Re: 145 Marginal Way, Portland, Maine

Five Liver Company, owner at 145 Marginal Way in Portland, Maine, has reviewed the T|W Design drawings dated April 12, 2017, containing drawings originally issued June 27, 2017, with revision dates July 14, 2017, and related documents (collectively, the "Drawings"), all attached hereto.

**Re: Planet Fitness Floor Structure  
Portland, Maine**

**BK Planet Fitness renovation plan review notes :**

GEAR SORTER  
 RECEPTION DESK  
 PLANS, SECTIONS & DETAILS

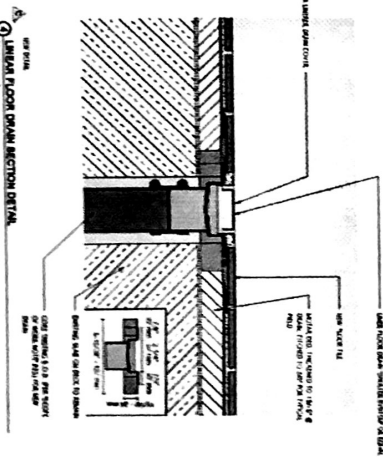
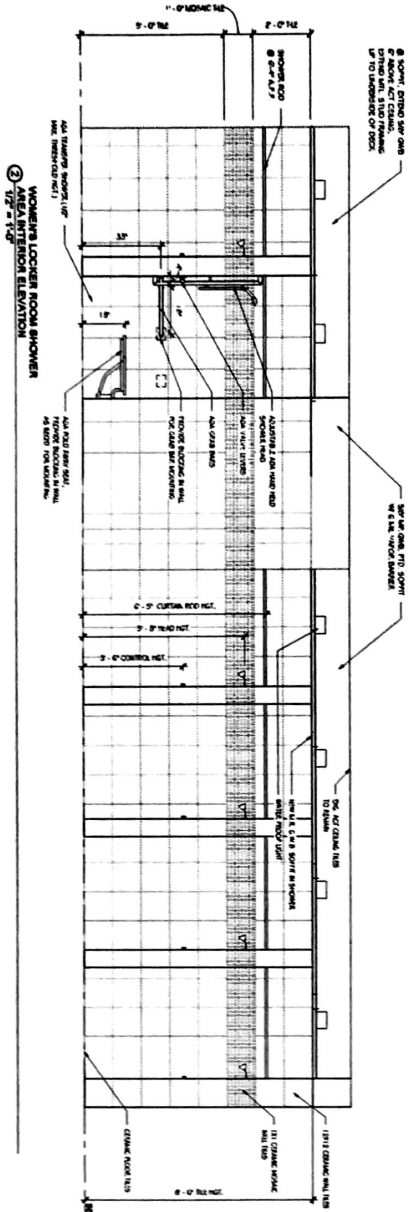
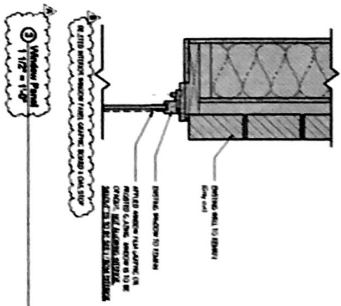
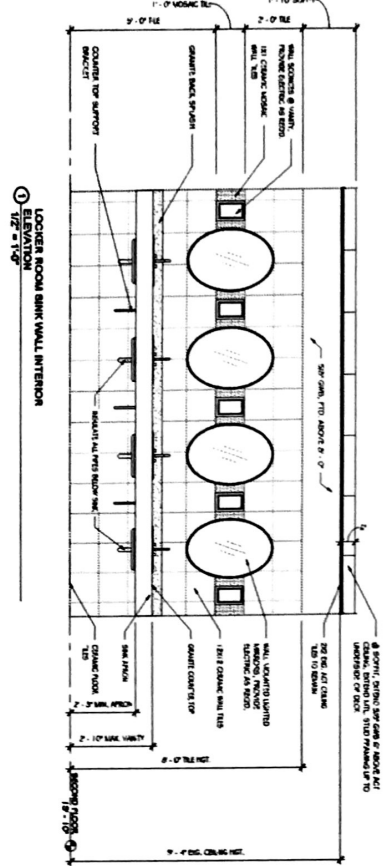
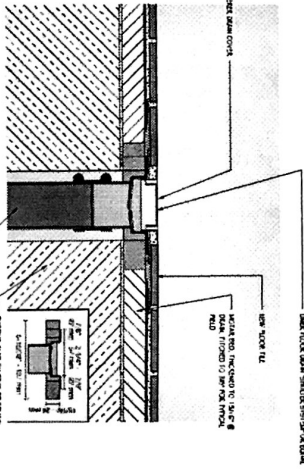
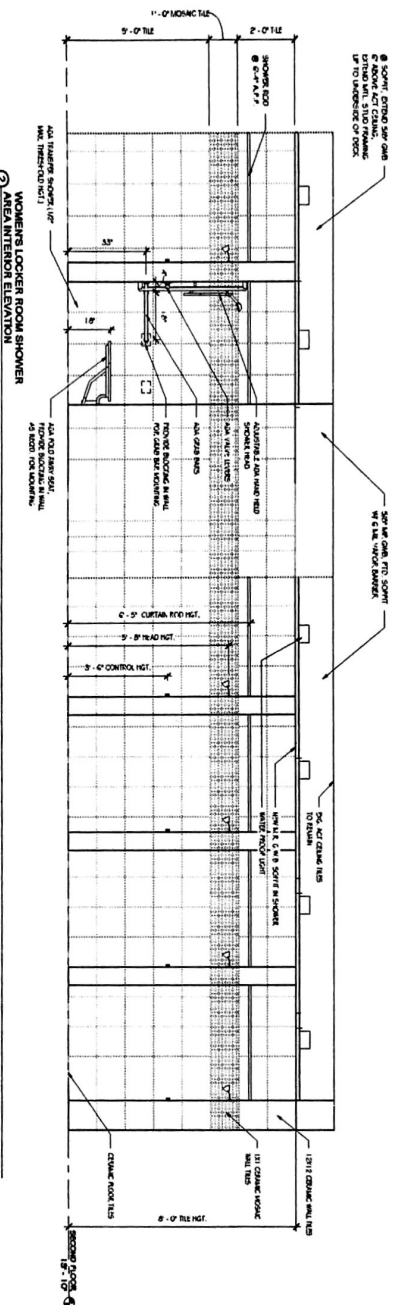
At your request, I have reviewed the second-floor structure at Planet Fitness in Portland to determine load capacity and adequacy to support PF gear soffit. I measured sizes on site and confirmed they were consistent with those in the original structural plans by Becker Structural Engineers of Portland.

First, this gear soffit is made of light gage metal framing and gypsum board. It is considered to be very light and would generally fall into "collateral" loads that would apply to ceilings, etc. However, having the original plans made it simple to determine actual capacity. The note sheet on the plans only requires 50 psf Live Load, and another 20 psf for partitions, in addition to structure weight. It is important to note these are minimum requirements and often the actual structure will far exceed the minimum design.

The weakest links of the structure are the W16x31 steel beams that are spaced approximately 9 feet apart and span 30 feet. These beams have (12) 3/4" diameter x 4-1/2" long welded studs on top to make them composite with the slab structure. The slab is 3" 20 gage composite deck with a total of 5-1/2" concrete thickness. Back calculating these beams, the result is they legitimately can carry a design Live Load of 100 psf, which is very conservative for the current use. Based on this, I can assure that the structure is completely adequate for weight of the gear ceiling soffit and much more.
